CITY COUNCIL OF THE CITY OF ALBUQUERQUE

FLOOR AMENDMENT NO. _____ TO C/S R-11-211

The Volcano Trails Sector Development Plan, attachment A to R-11-211 as amended by C/A(1) R-11-211 (adopted 5-11-11), is amended as follows:

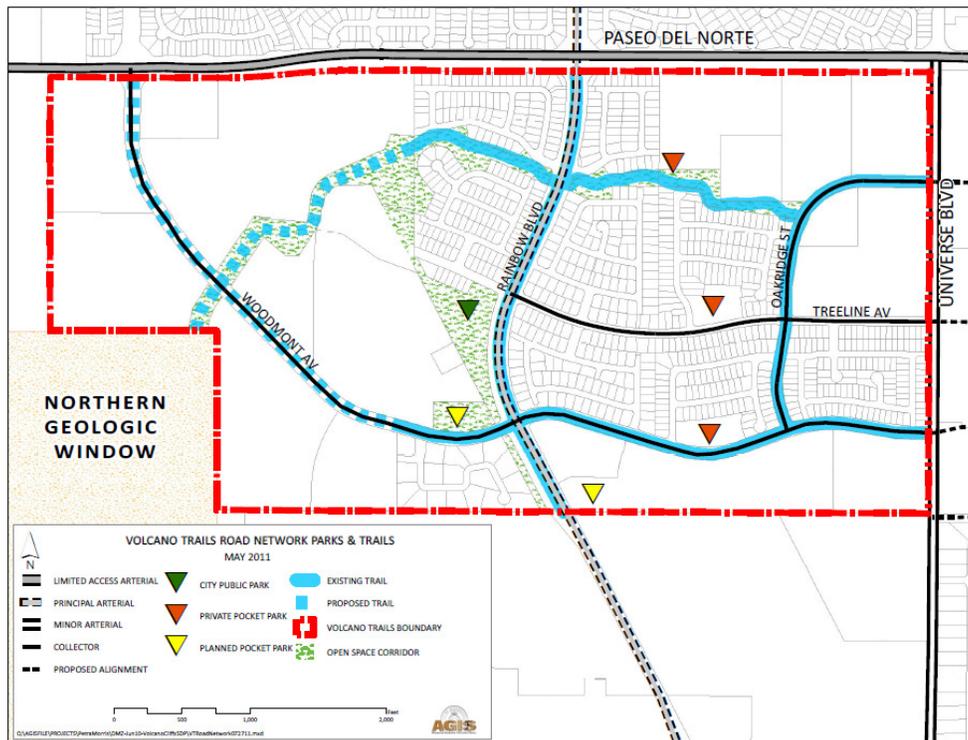
1. On page 4 delete the first sentence of the fourth paragraph and insert in lieu thereof "Albuquerque Public Schools (APS) has three schools south of the Plan area, including Volcano Vista High School, Tony Hillerman Middle School and Tierra Antigua Elementary School. There are also undeveloped lands held by the State of New Mexico to the south of the Plan area."
2. On page 6 delete Exhibit 5 and insert in lieu thereof the following map to provide more details regarding the trail system:

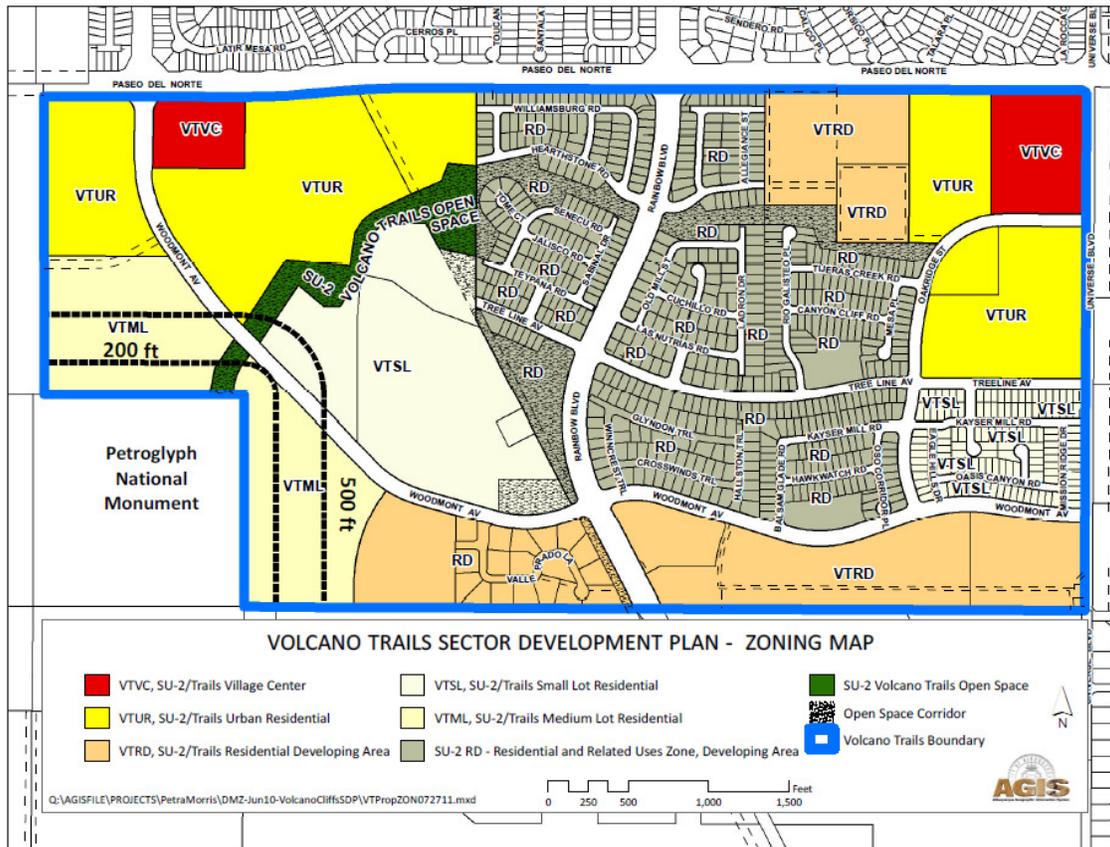
- “services”. In the last sentence delete “and civic uses such as daycare”.
13. On page 21 in the description for “SU-2 Volcano Trails/Suburban Residential-Medium Lot (VTML)” delete “and contains visible private open space”. Insert “and” before “preserves significant view corridors”.
14. On page 24 delete Exhibit 10 and insert in lieu thereof the following map with corrections to the platted open space corridor:
